DATE: February 17, 2026
TO: ALL CONTRACTORS
FROM: DUSTINE TILL
PROJECT: ROSCOE ROAD WATER TREATMENT PLANT
ORANGE BEACH WATER AUTHORITY
GMC PROJECT NO. CMOB230049
RE: ADDENDUM #3

ADDENDUM NUMBER 3

ROSCOE ROAD WATER TREATMENT PLANT

GMC PROJECT NO. CMOB230049

7B PLAN
D-711 SCALE: 3/16" = 1'-0"

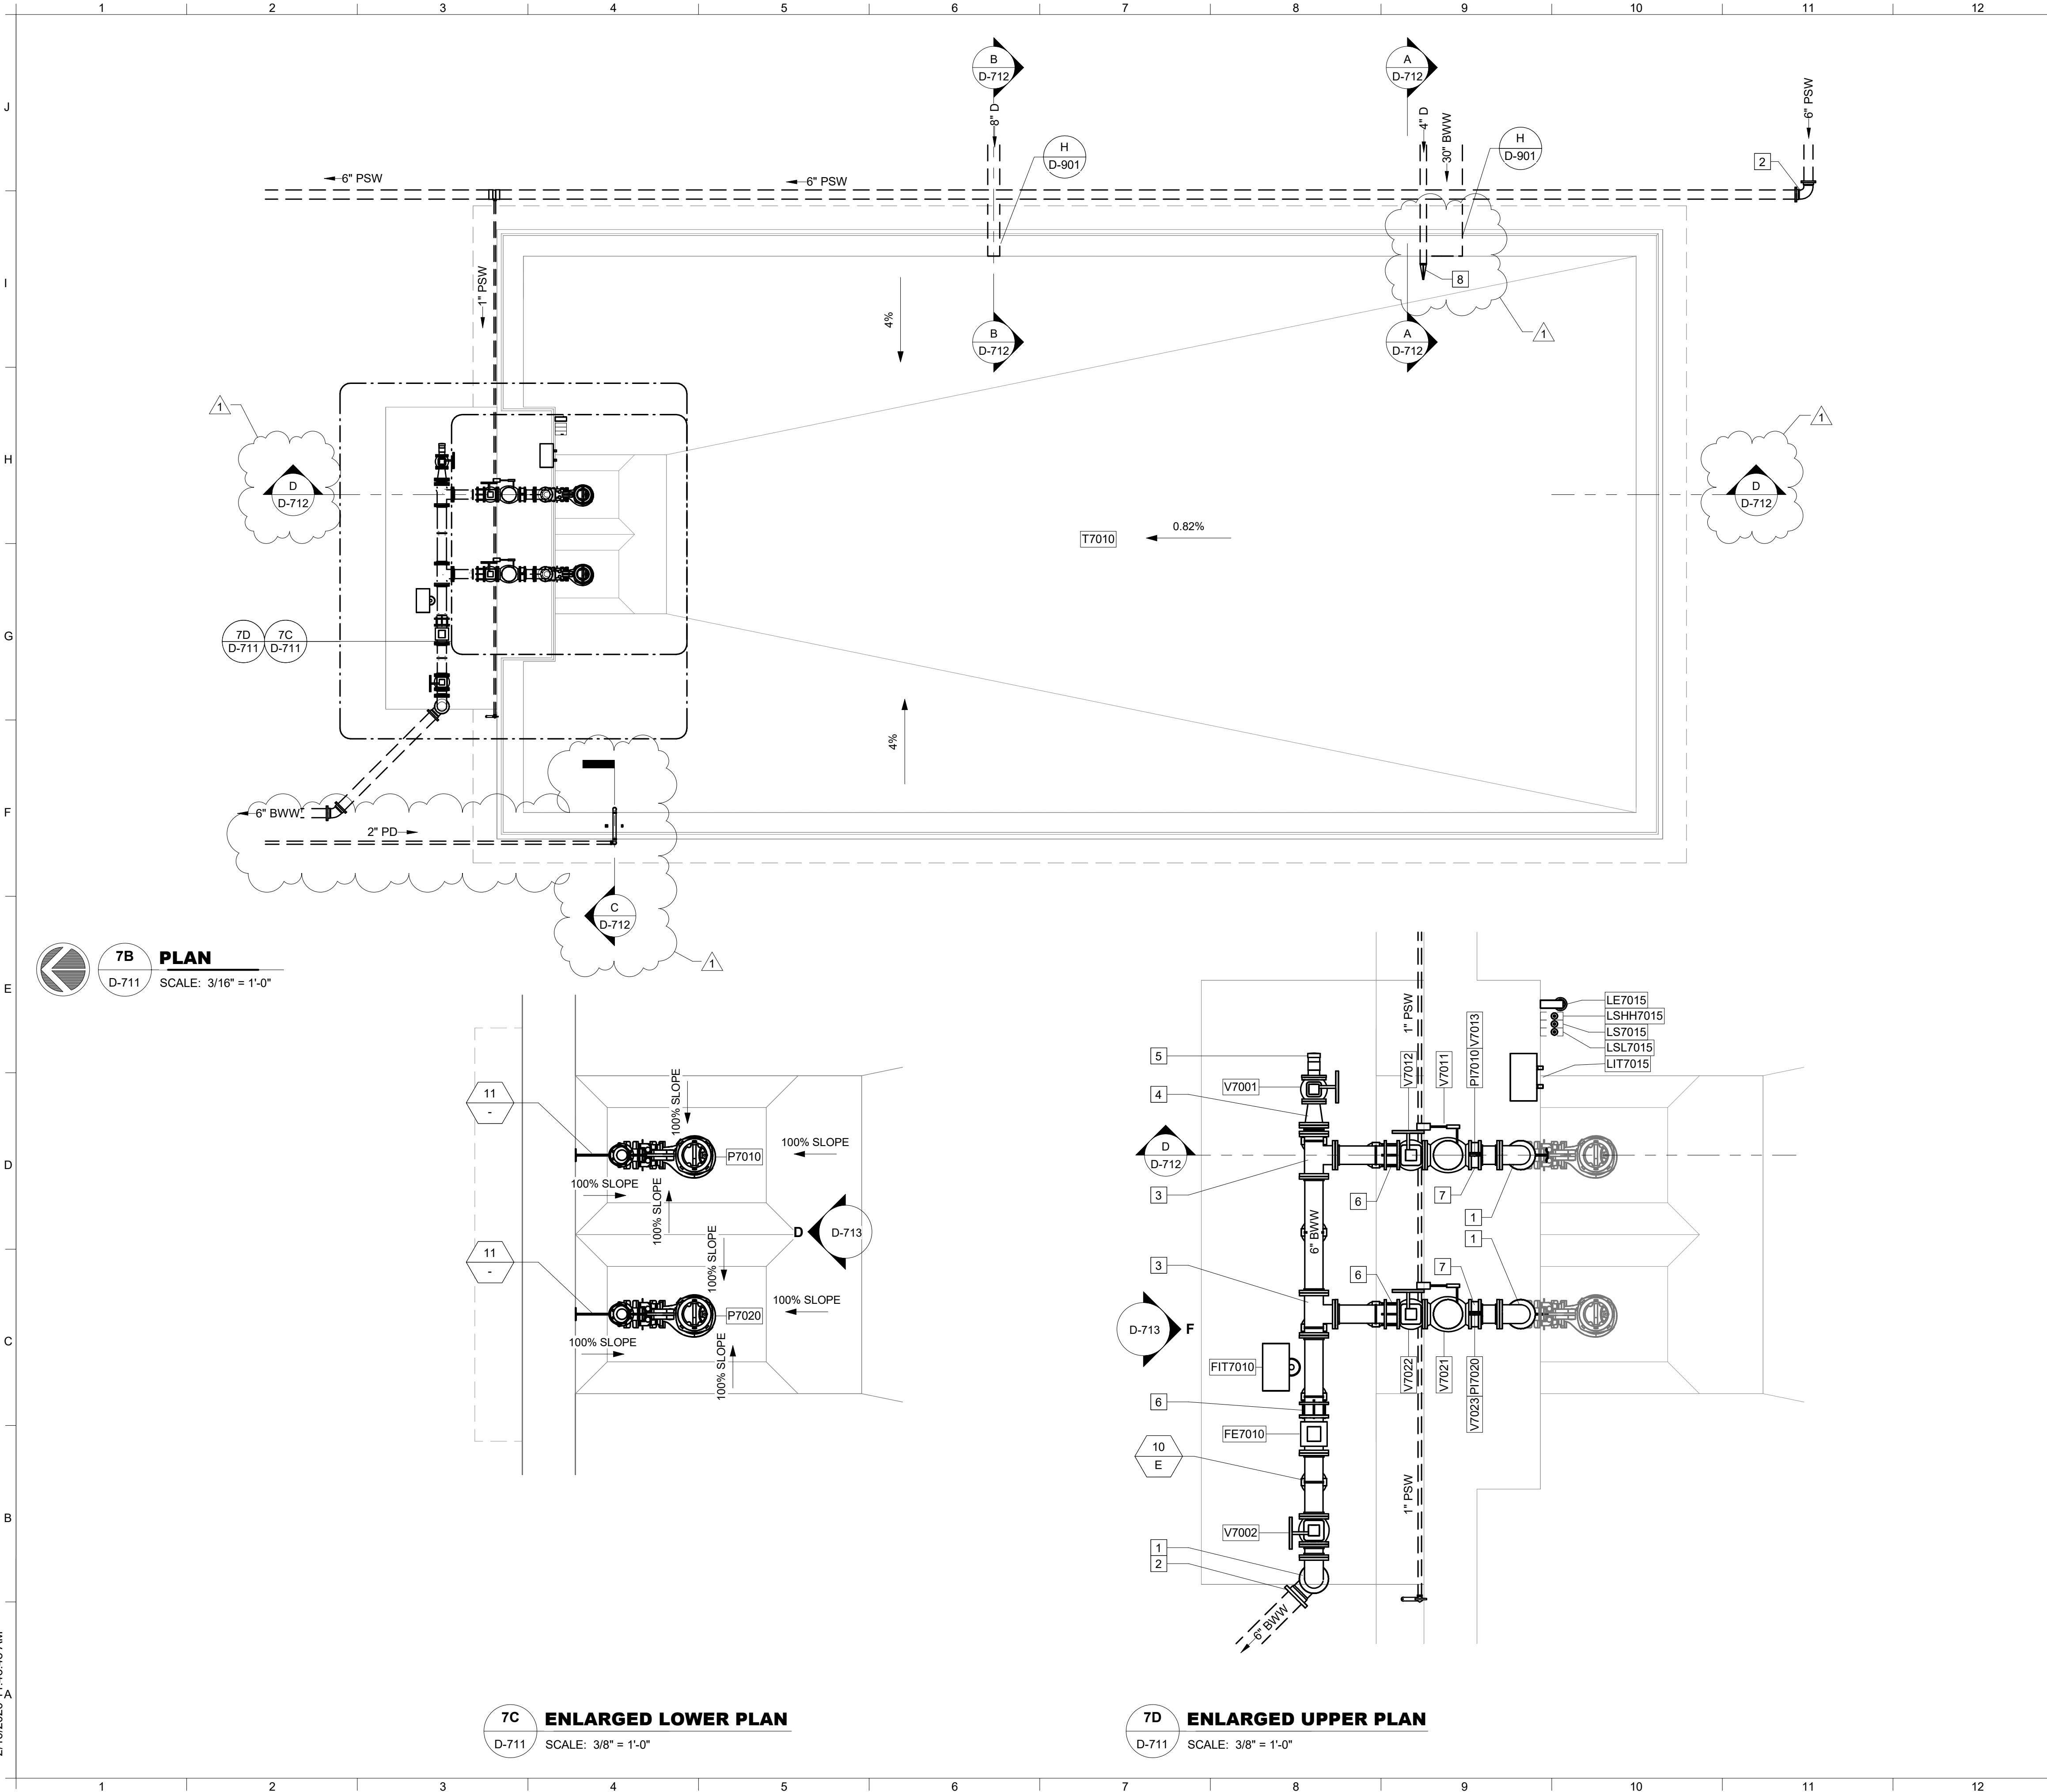
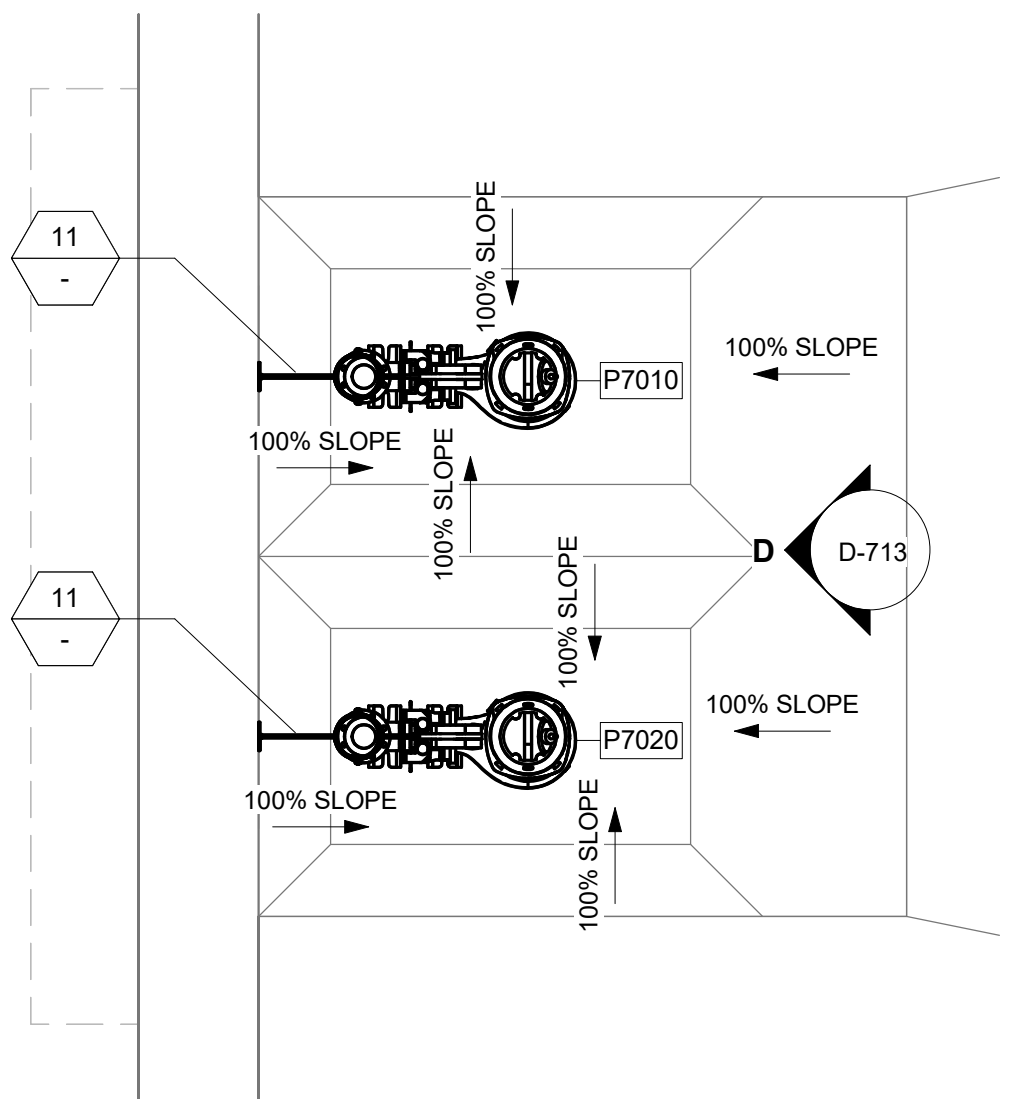
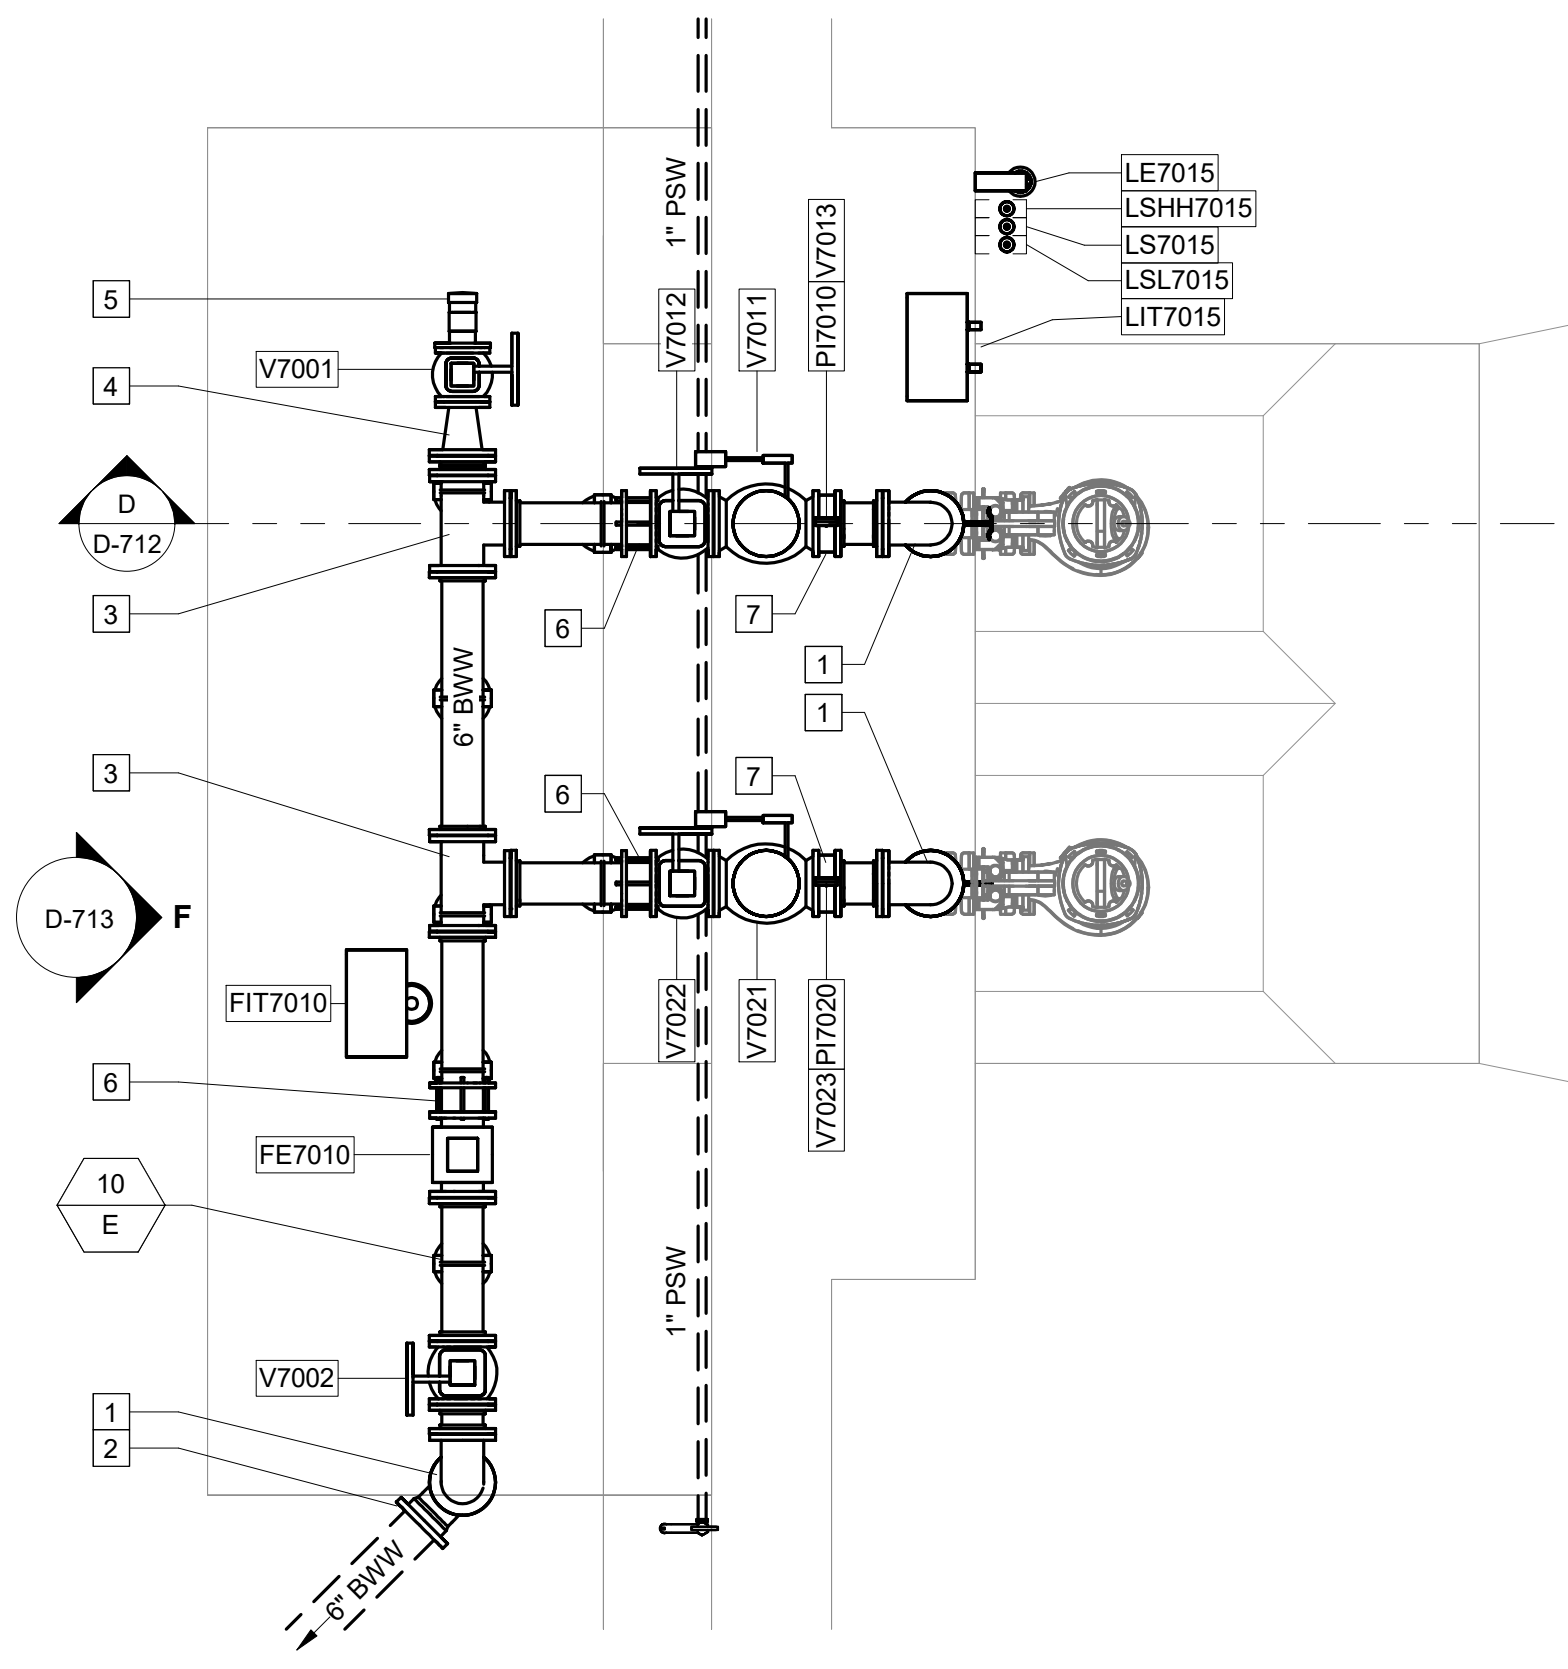
Answer: Yes, the 8" Drain line suspended from the pipe gallery ceiling shall be SCH 80 PVC.
- 5.25 **Question: Please confirm valves V7012 and V7022 should be provided with flanged ends. They are shown on sheet D-711 in a flanged system but are called MJ in the Valve Schedule.**

Answer: Yes, Valves V7012 and V7022 should be flanged valves.

- 5.26 **Question: Please confirm valve V7001, shown on sheet D-711, should be 4” verses the 6” designation in the Valve Schedule. Valve is shown on sheet D-711.**

Answer: Yes, Valve V7001 should be 4”.
- 5.27 **Question: Please confirm valve V7002 should be added to the Valve Schedule as a 6” flanged plug valve with handwheel. Valve is shown on sheet D-711.**
